ADDENDUM #1

City of Washington, Missouri 2024 Parking Lot Project February 1, 2024

SHEET 2 of 7

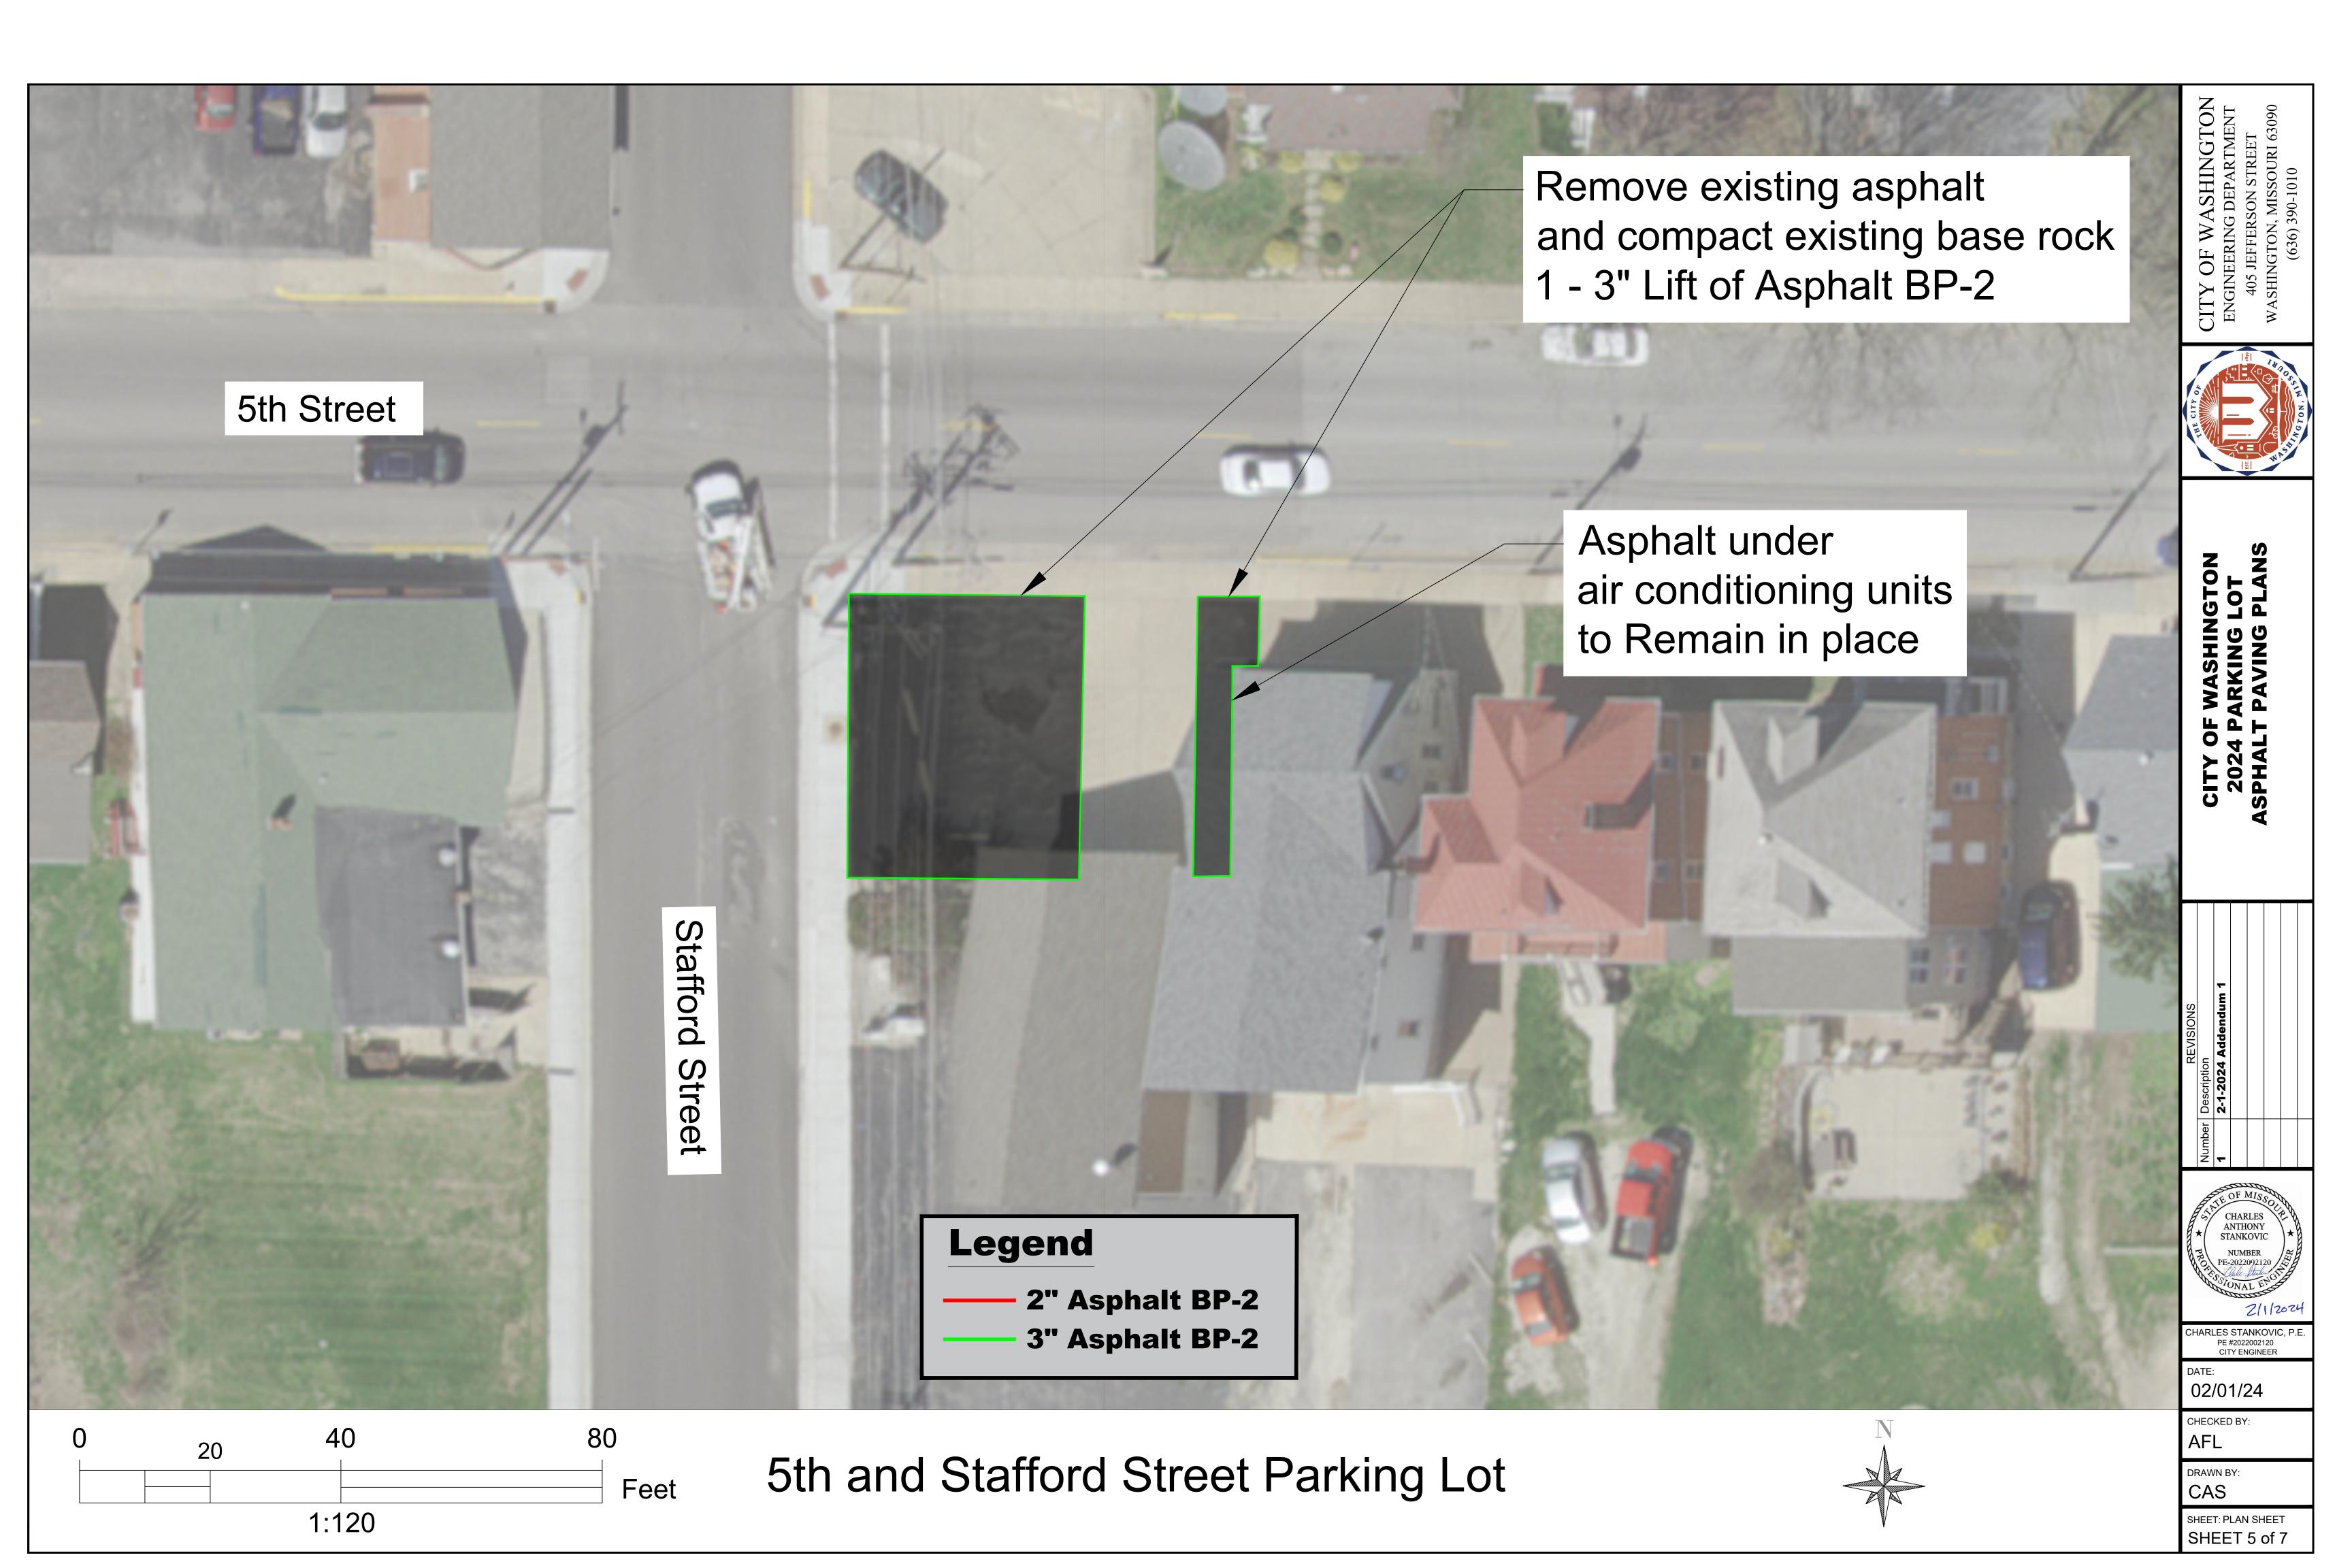
- 1. Plan sheets 2 and 5 and specifications bid sheet have been modified to include the following. These changes are a result of changing the scope of work at 5th and Stafford Street parking lot to replace milling with completed asphalt tear out and increasing pavement thickness from 2" to 3" of asphalt.
 - a. Bid Sheet Line Item #3- Milling
 - i. Original quantity/units = 6,935 TON
 - ii. New quantity/units = 6,730 TON
 - b. Bid Sheet Line Item #4- Asphalt BP-2
 - iii. Original quantity/units = 2,285 TON
 - iv. New quantity/units = 2,300 TON
 - c. Bid Sheet Line Item #10- Remove existing asphalt and compact existing base rock
 - v. New quantity/units = 205 SY
